Submissions on Bryndwr Road renewal draft scheme

Aug 01, 2025 - Aug 17, 2025

Bryndwr Road Renewal

Submission from Spokes Canterbury

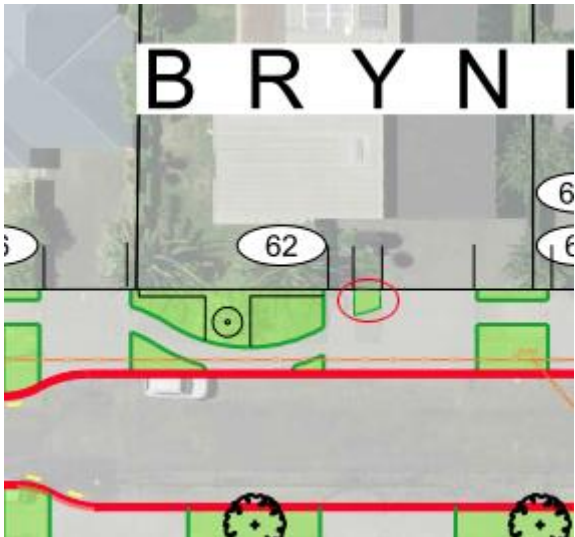
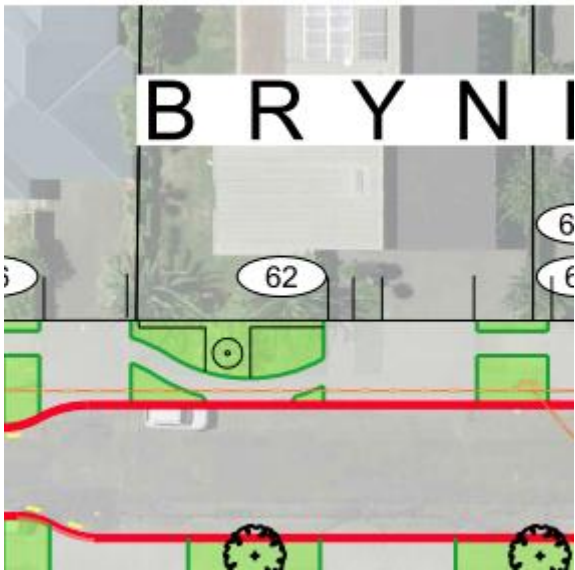
1. can I suggest extending patch of grass near the driveway to provide better flow for the footpath, please see my mock diagram (emailed) , see before and after in the circled area screenshot below
2. also with this work, a lot of the current driveway will need to be resealed, I think this is a good opportunity to resealed my entire driveway, on my side of the property, I'm happy to pay for the added cost. I think this will provide the best out come otherwise the driveway will look mismatched with the different surfaces on the driveway.

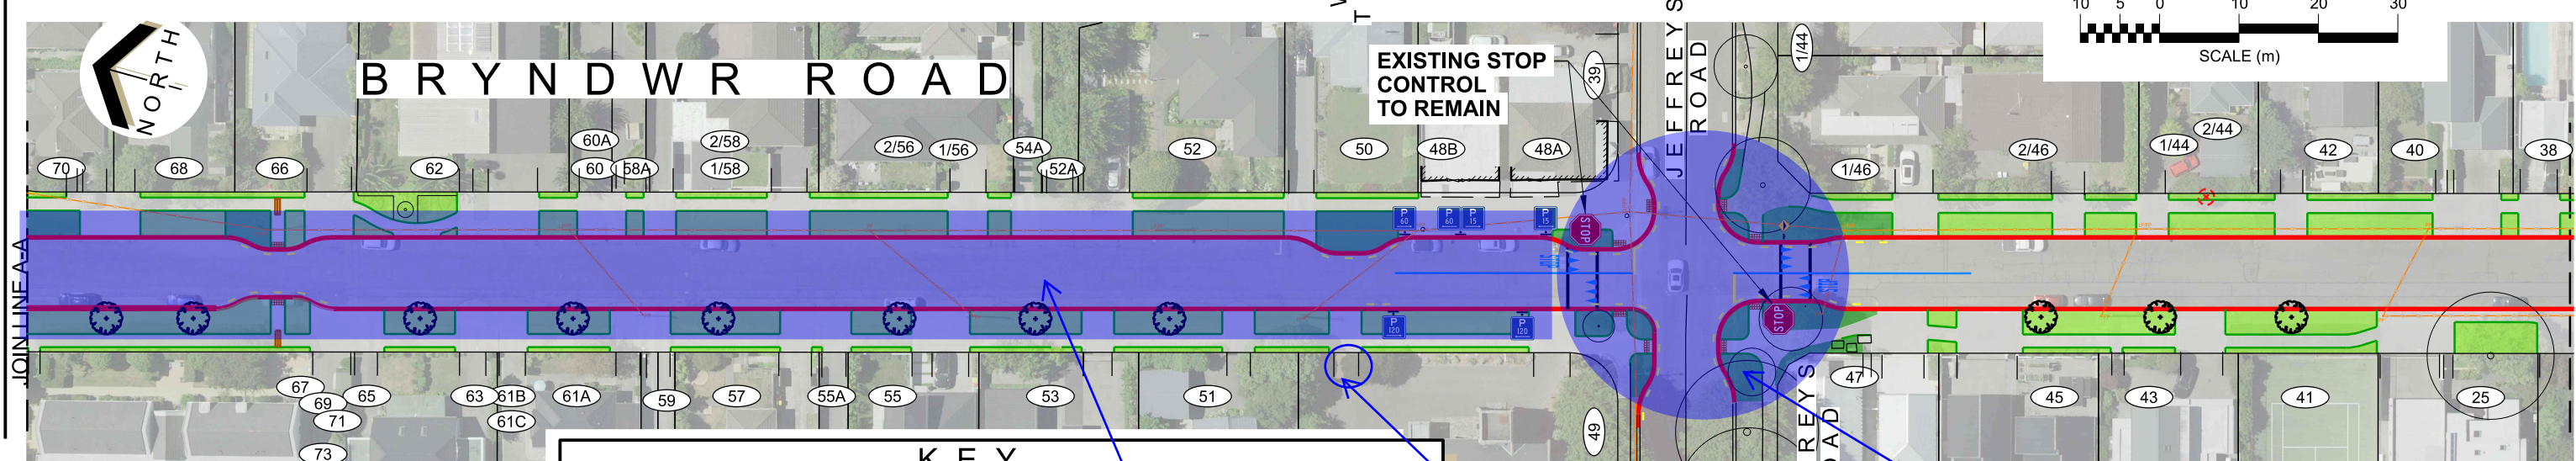
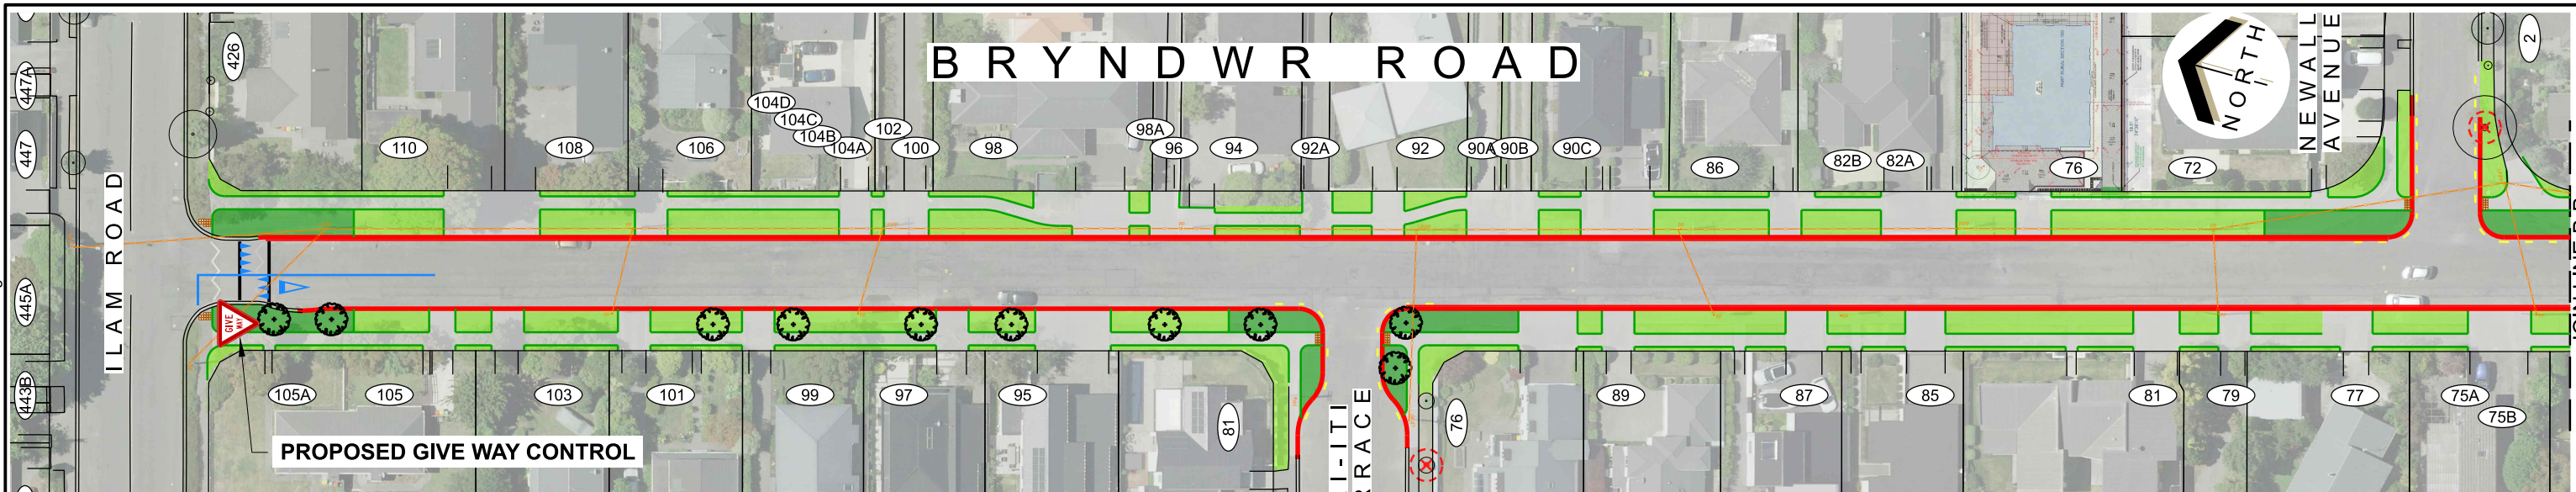
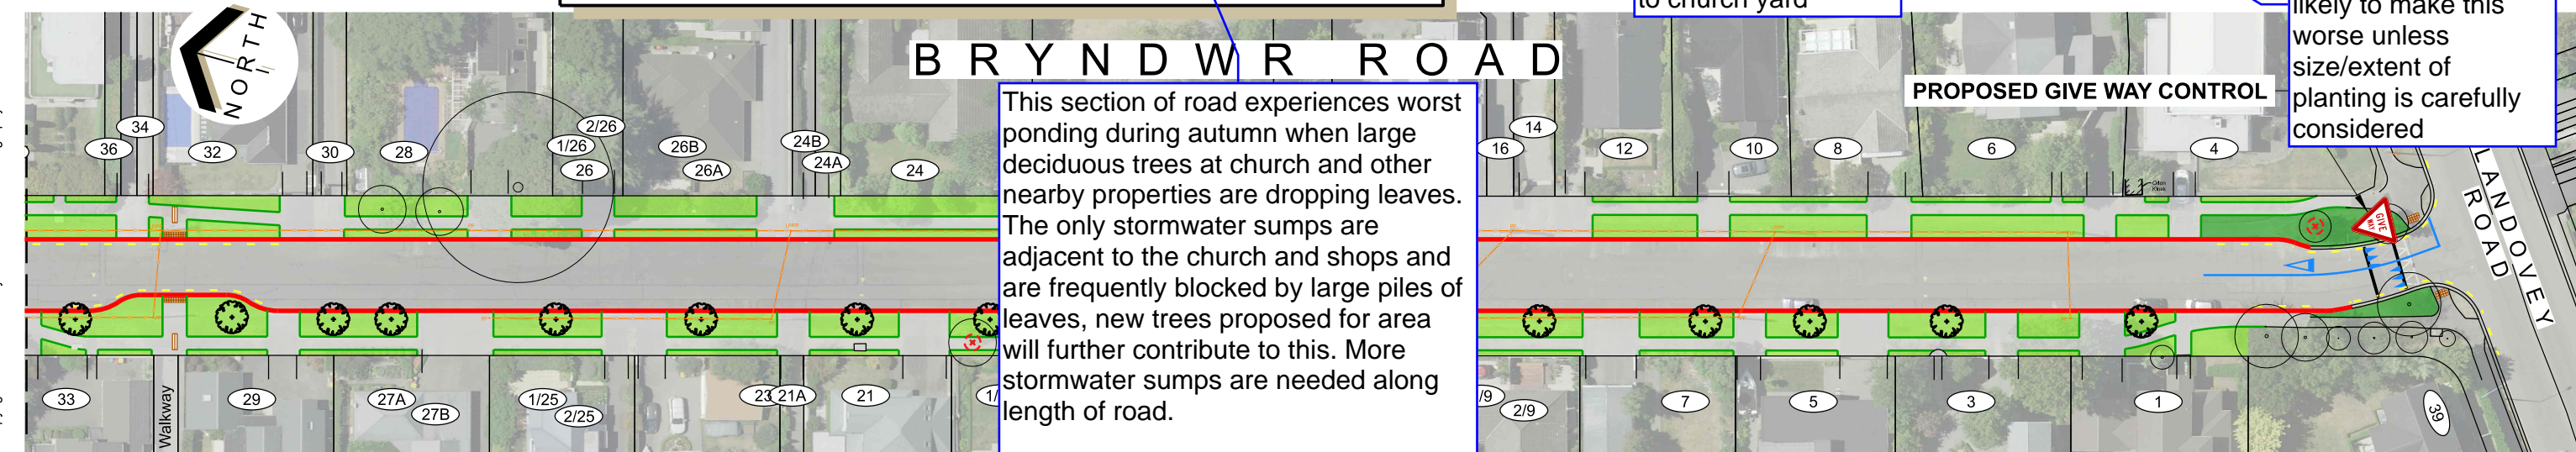
I have attached a PDF of the draft plan with comments that is would like considered as the draft design progresses further.

This driveway has been fenced over, only pedestrian gate to church yard

this intersection already has poor visibility, further landscape planting is likely to make this worse unless size/extent of planting is carefully considered

This section of road experiences worst ponding during autumn when large deciduous trees at church and other nearby properties are dropping leaves. The only stormwater sumps are adjacent to the church and shops and are frequently blocked by large piles of leaves, new trees proposed for area will further contribute to this. More stormwater sumps are needed along length of road.
